M-2008-025 Post 2018 Inspection Map

Satellite Imagery from 8/28/2013
Non GPS features based on AM-01 Exhibit C overlay

Photo 3. House trailer in poor condition within permit boundary (south side, looking west).

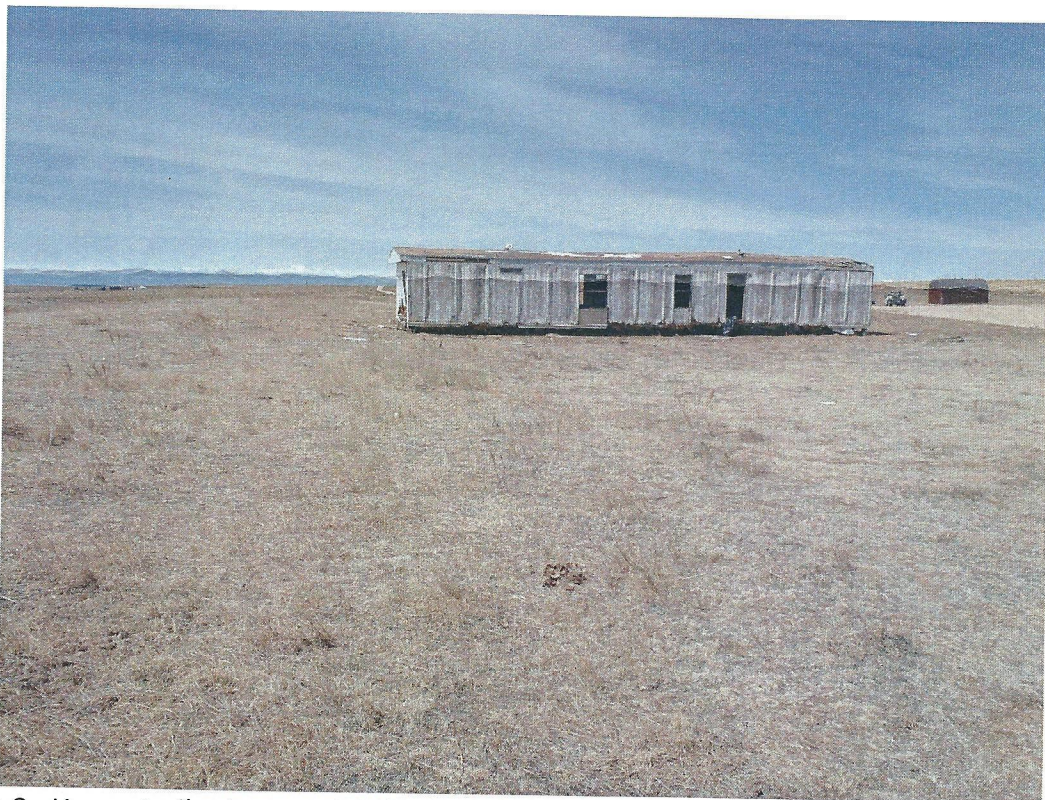
Photo 2. North (left) and west (right) highwalls sloped at 3H:1V or flatter.

Photo 6. West side diversion ditch (looking north).

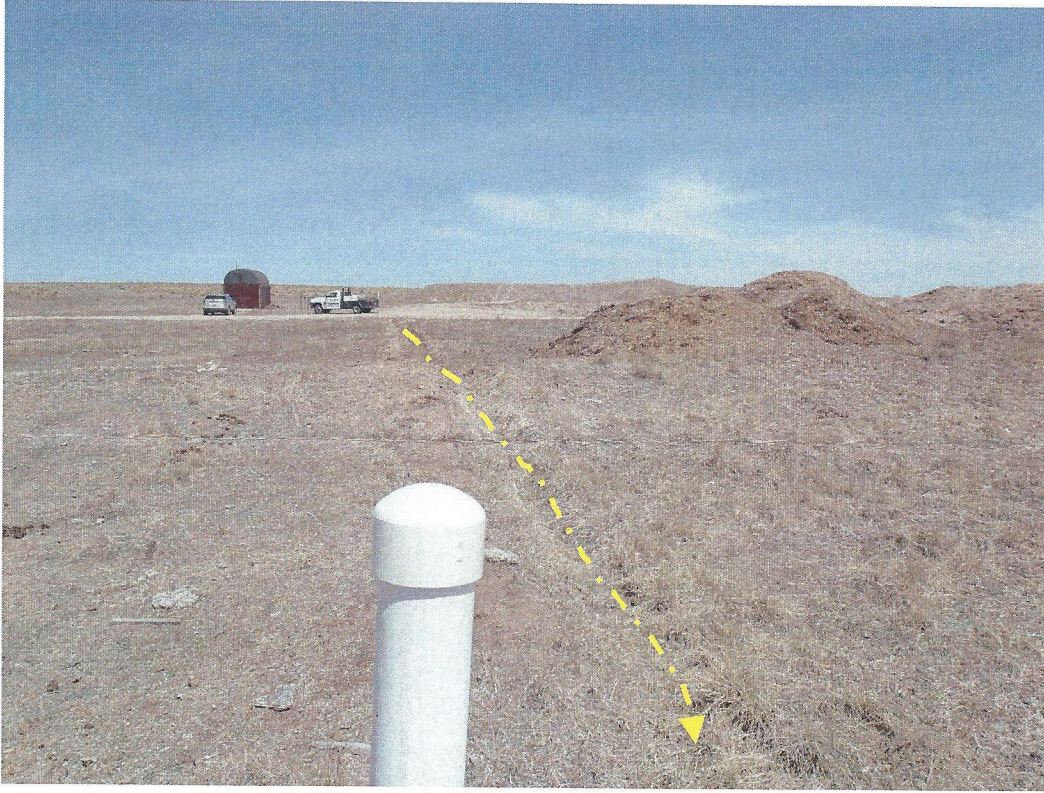
Storm Water MGT Plan: No oil or fuel spills observed. Ditches (see **Photo 6**) were observed intended to divert runoff away from the pit and towards a stormwater pond on the southwest corner of the existing pit. Stormwater captured within the pit, infiltrates.
